IN THE DRAWINGS

Annotated marked-up Drawings for FIGS. 1 and 6A, Replacement Sheets for FIGS. 1 and 6A, including FIG. 6B, are attached.

FIG. 1

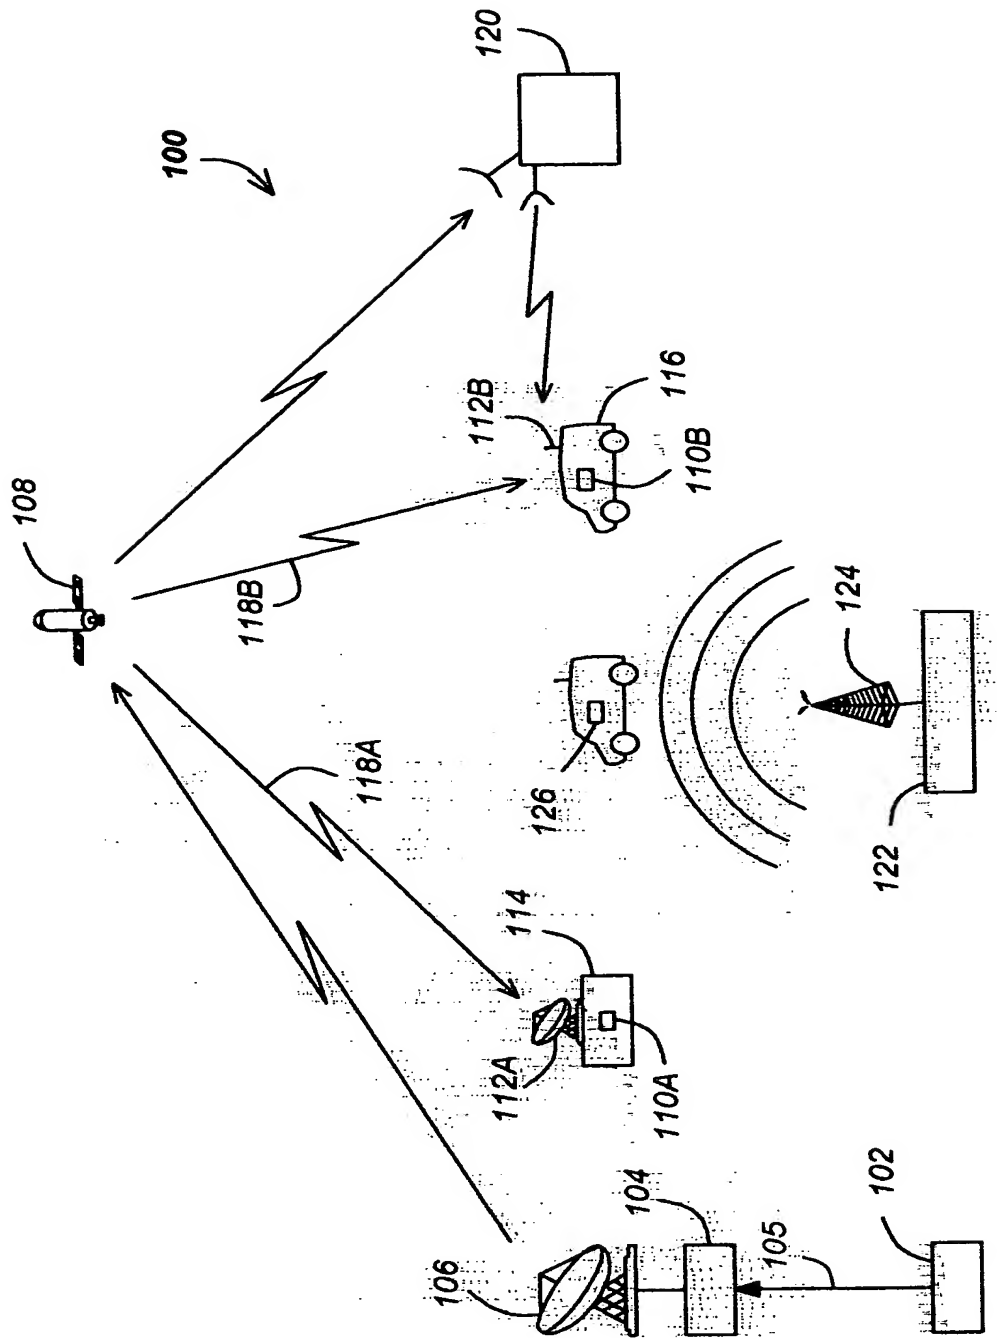
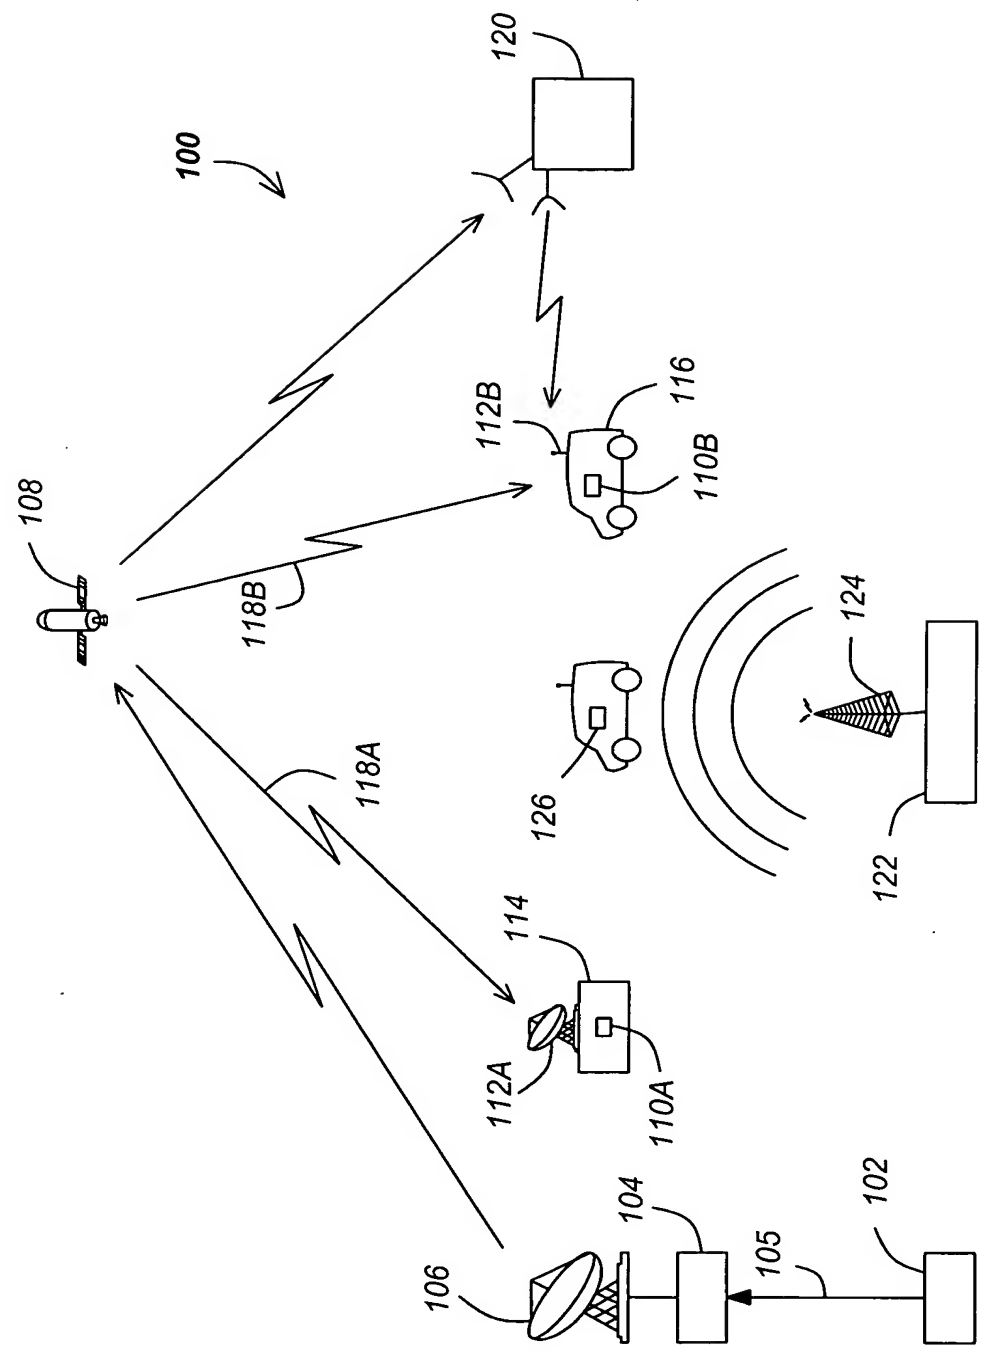
In FIG. 1, ground link 105 has been substituted for the ground link designated 114, as shown in the attached drawings. Please substitute FIG. 6A for FIG. 6, and add FIG. 6B.
